# **A G E N D A**

## **Architectural Review Board**

**May 24, 2016**

729 Felder Avenue

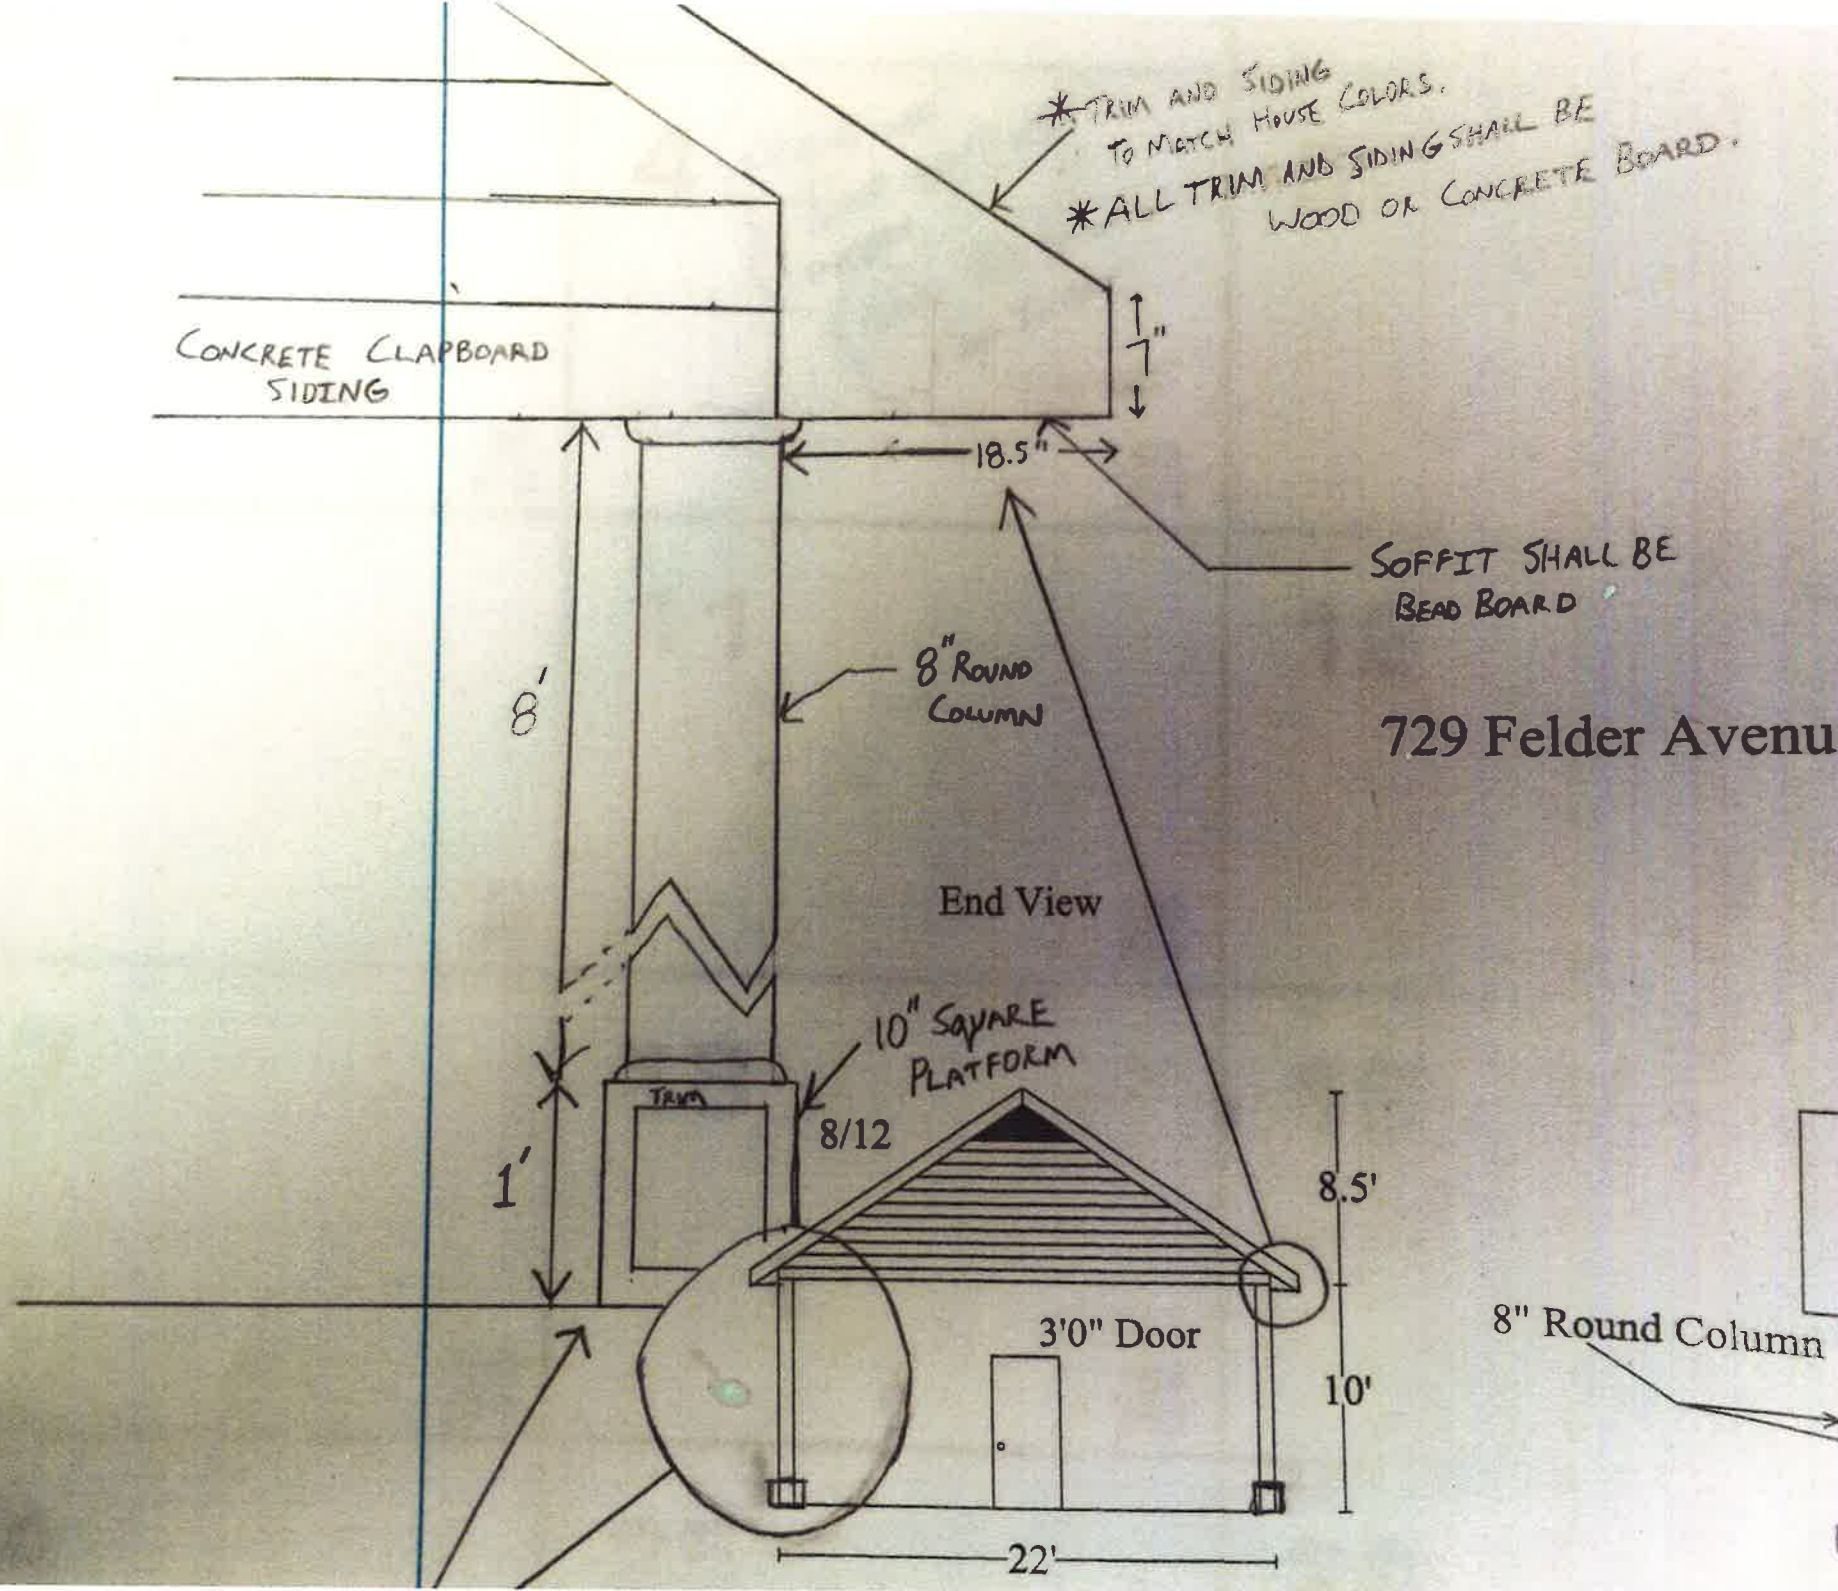
- This is a corner lot.
- The Board has approved carport/accessory structures that were compatible with the style of the house, and appropriately scaled to the house.
- No objection on the tree removal.

3276 Montezuma Road, Driveway

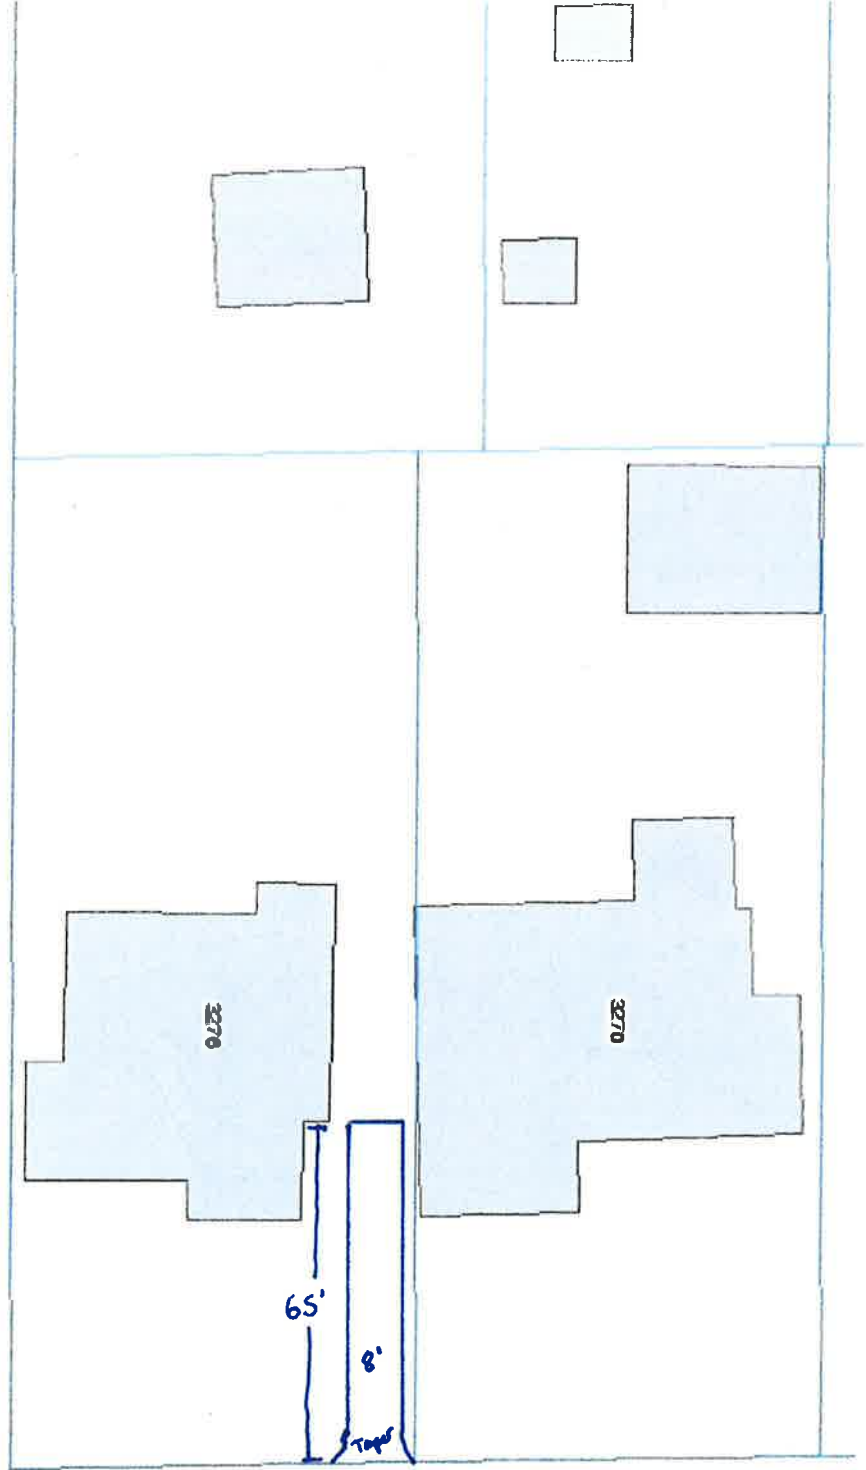
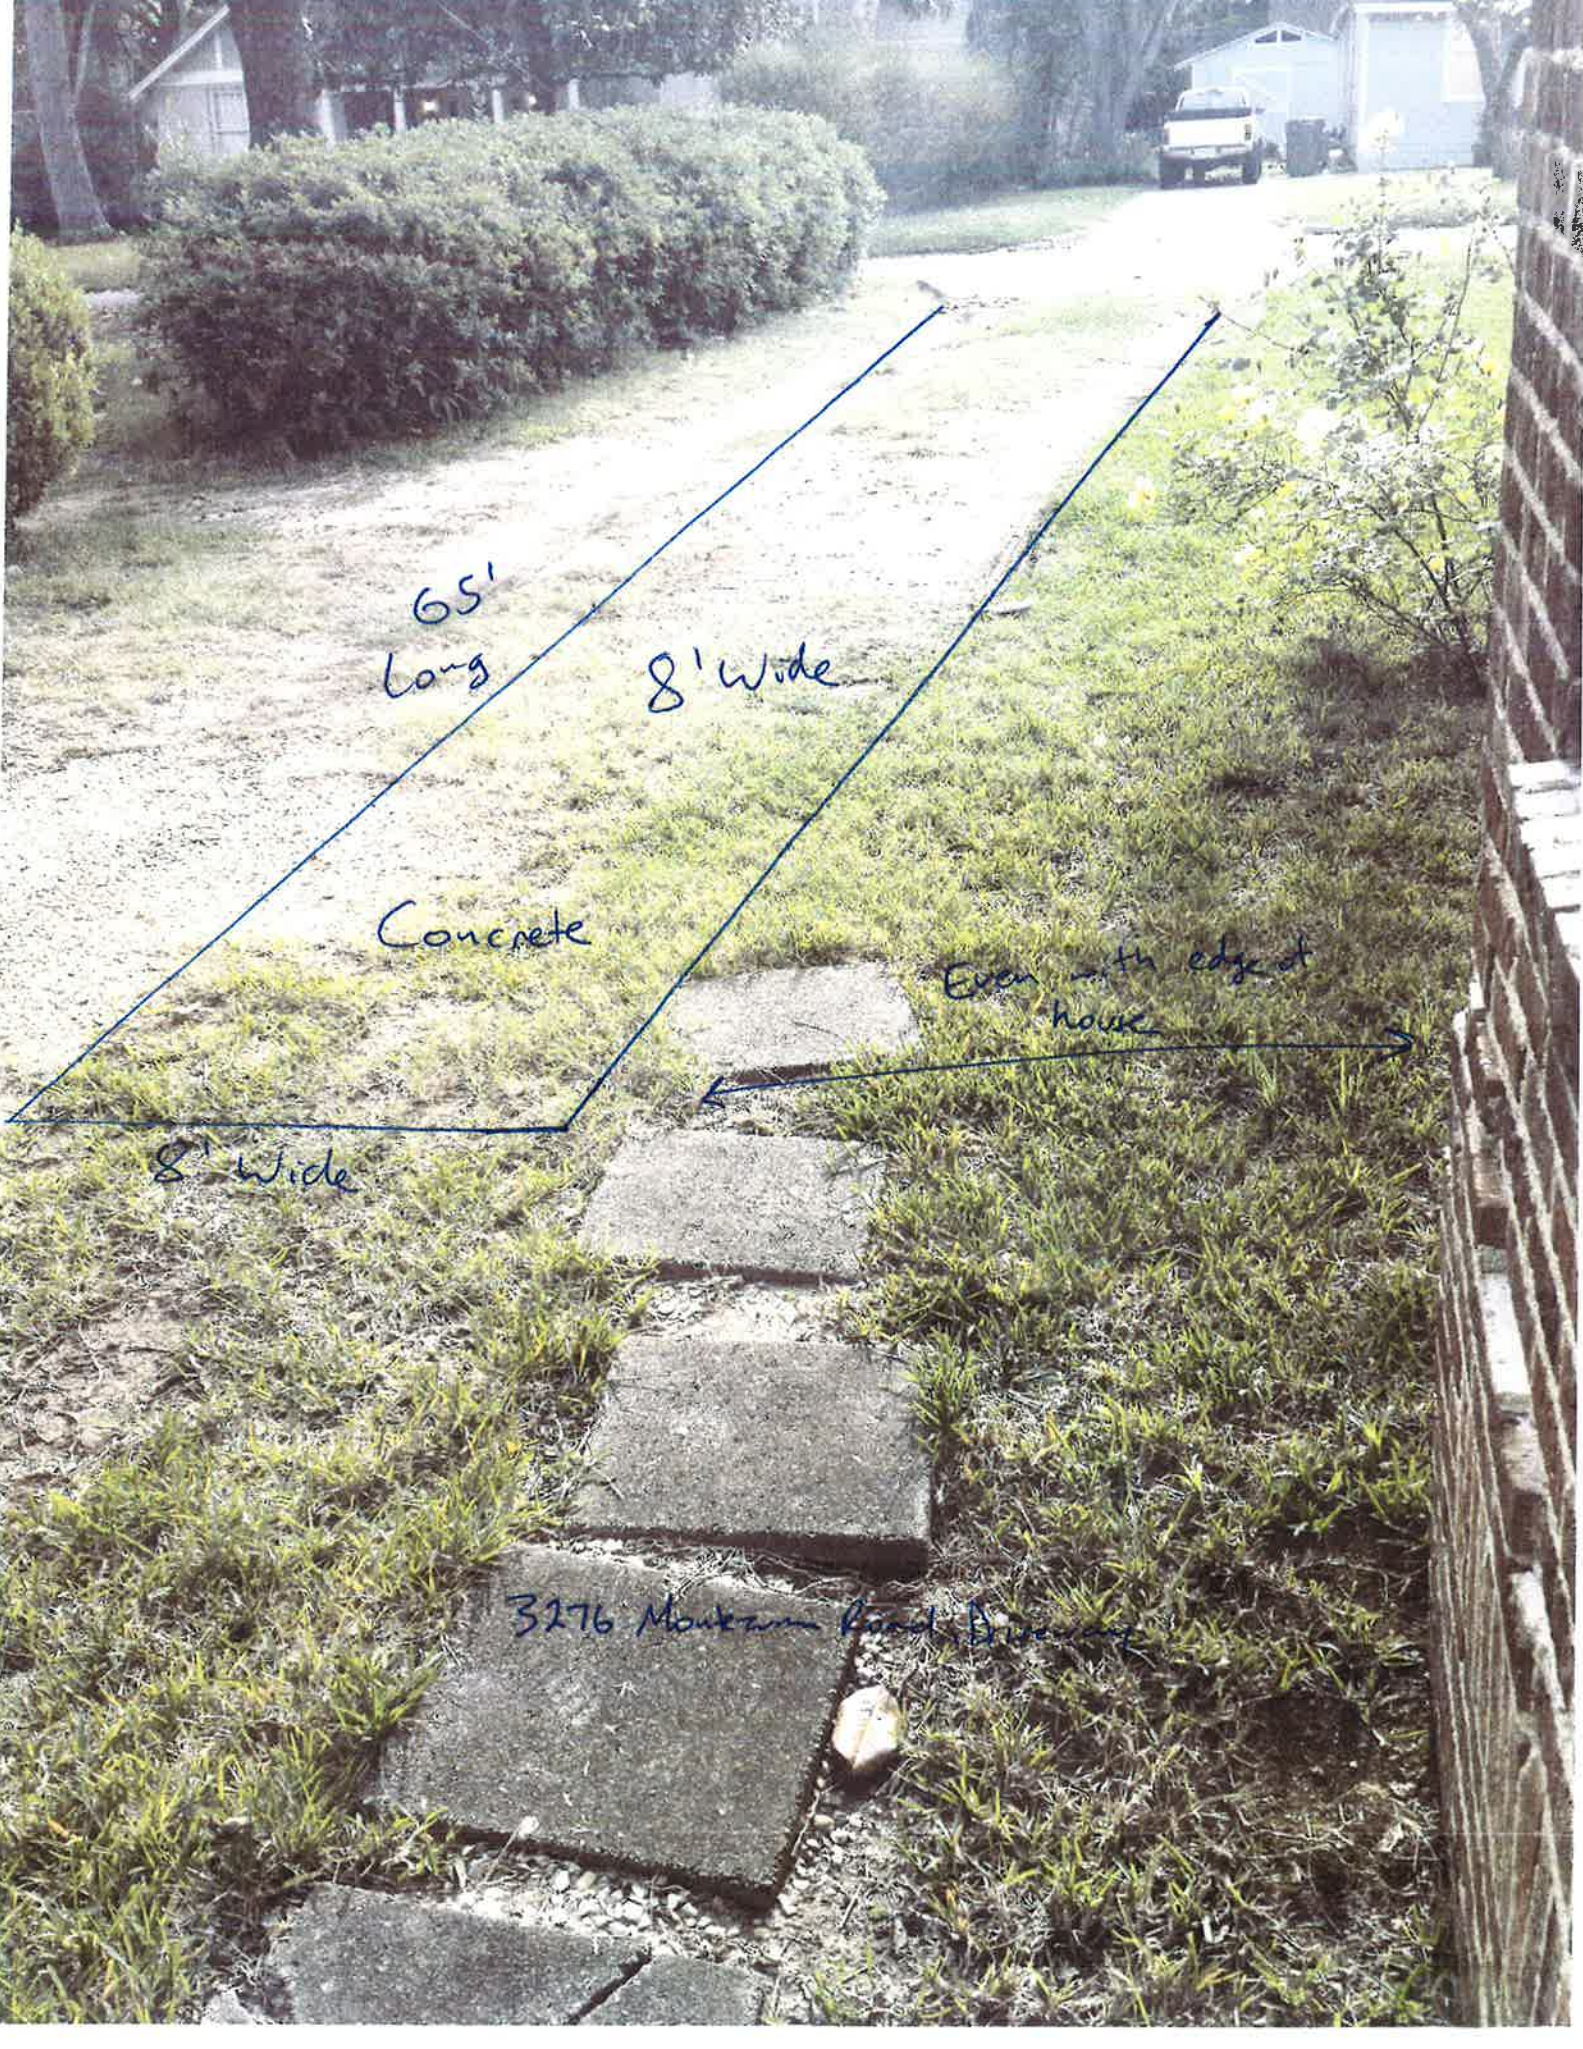
- As a standard parking place is 9' wide, the petitioner may want to consider a slightly wider driveway to keep tires off the grass.

*19 South Capitol Parkway*

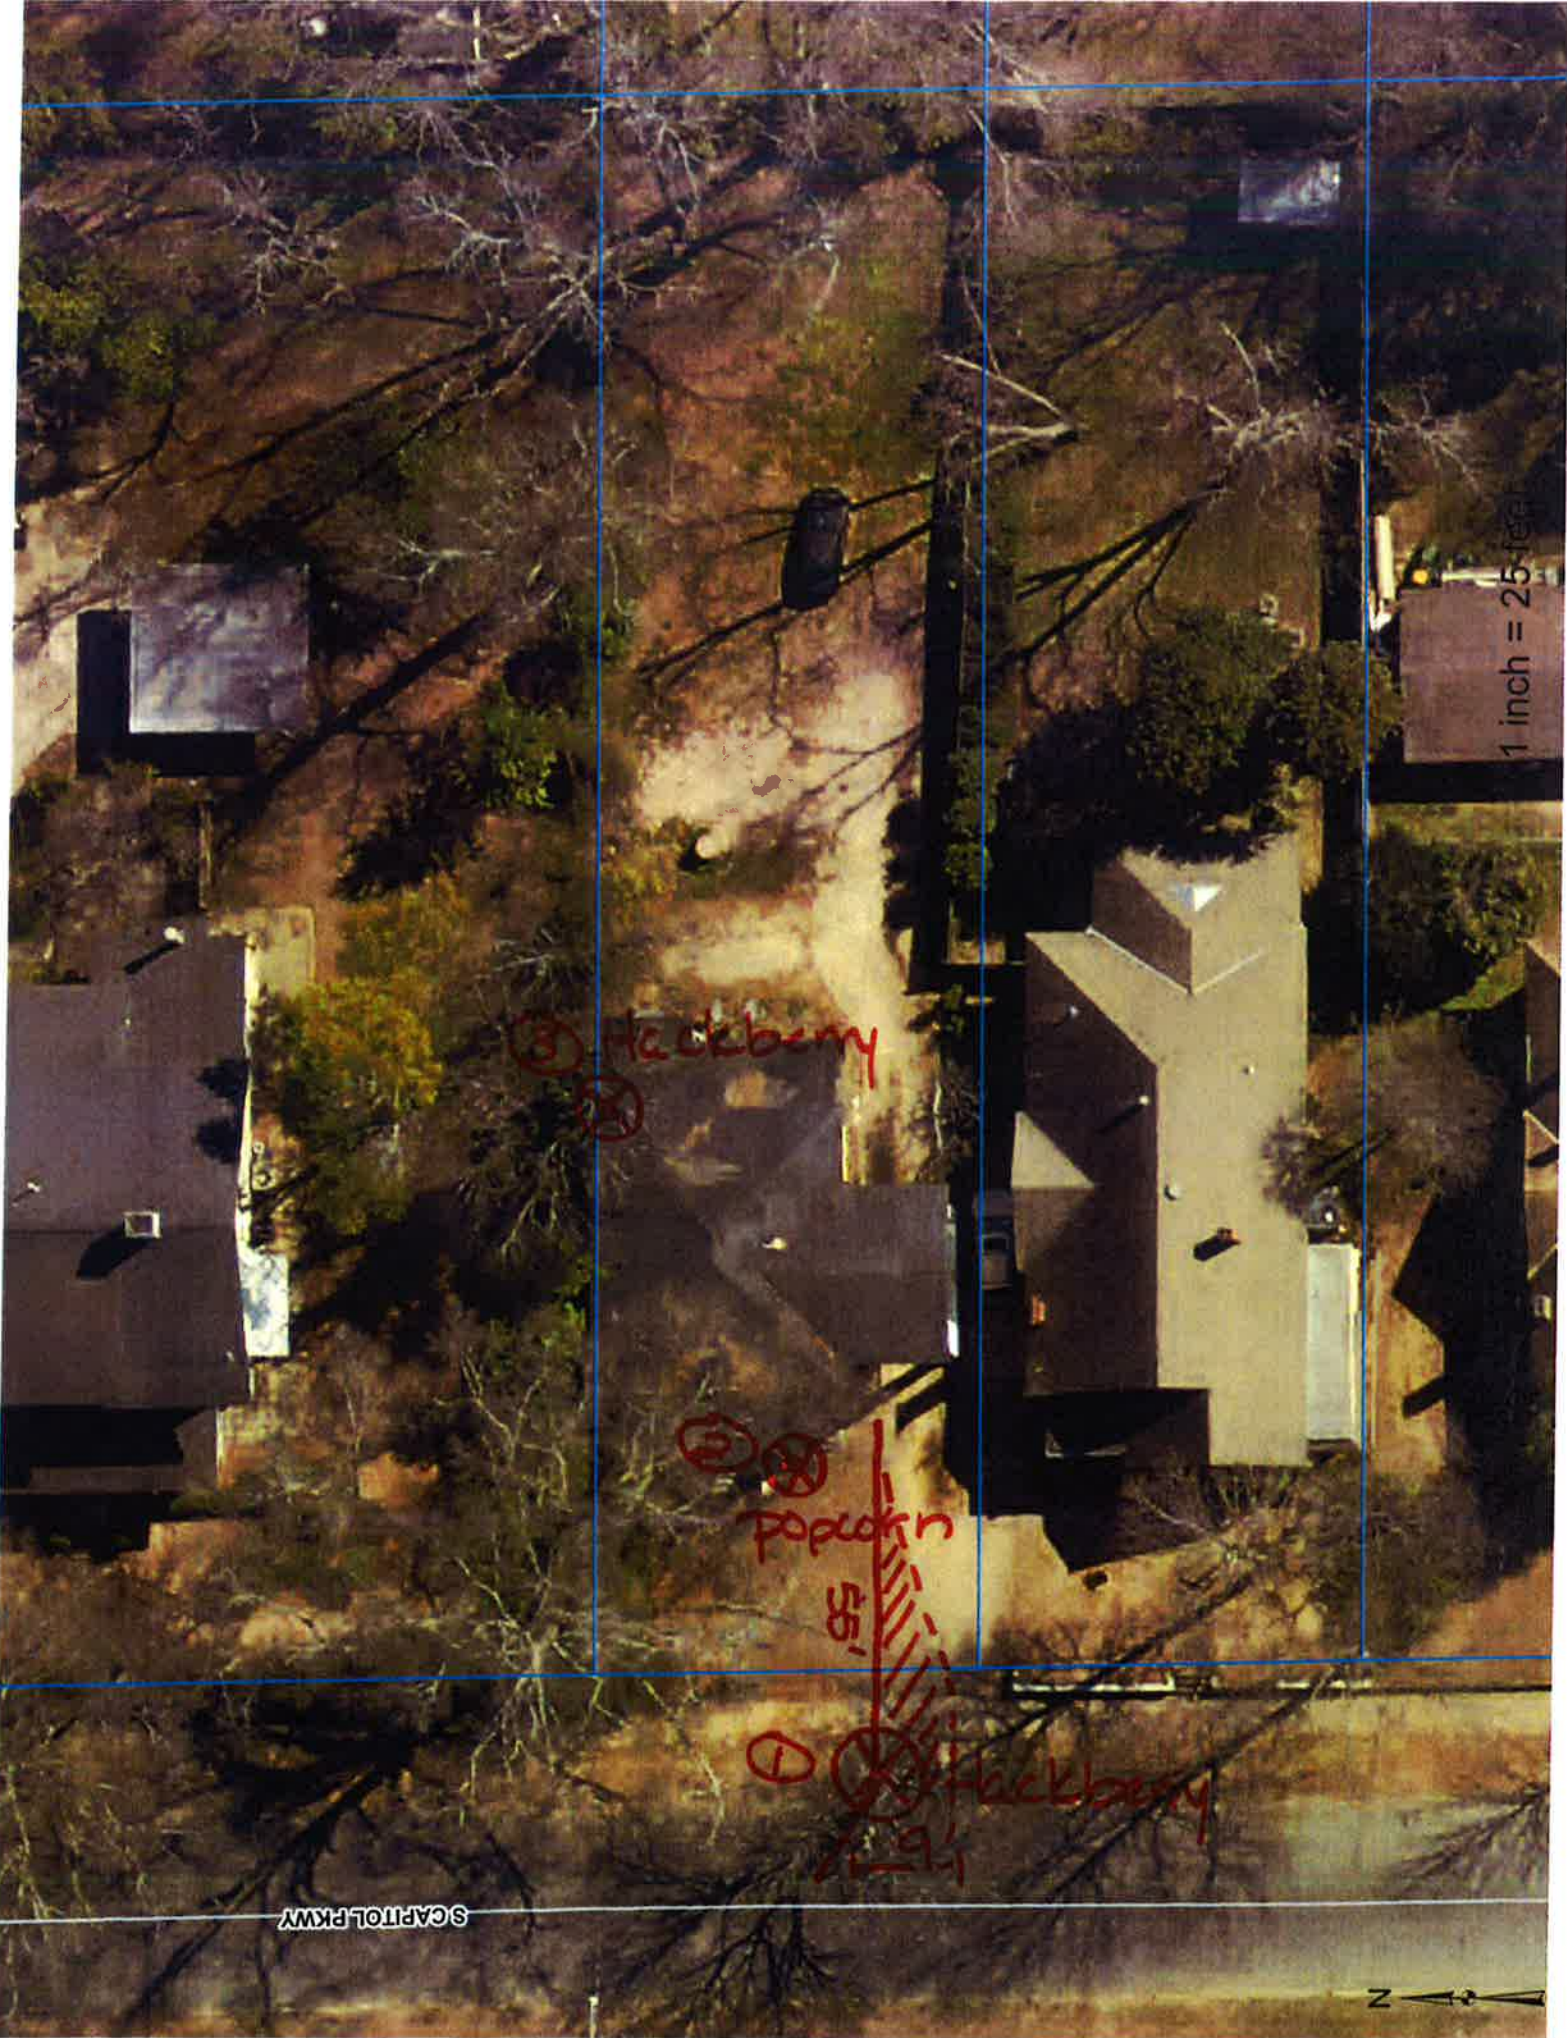
- No objection to the tree removals.
- Staff thinks this is an excellent project!
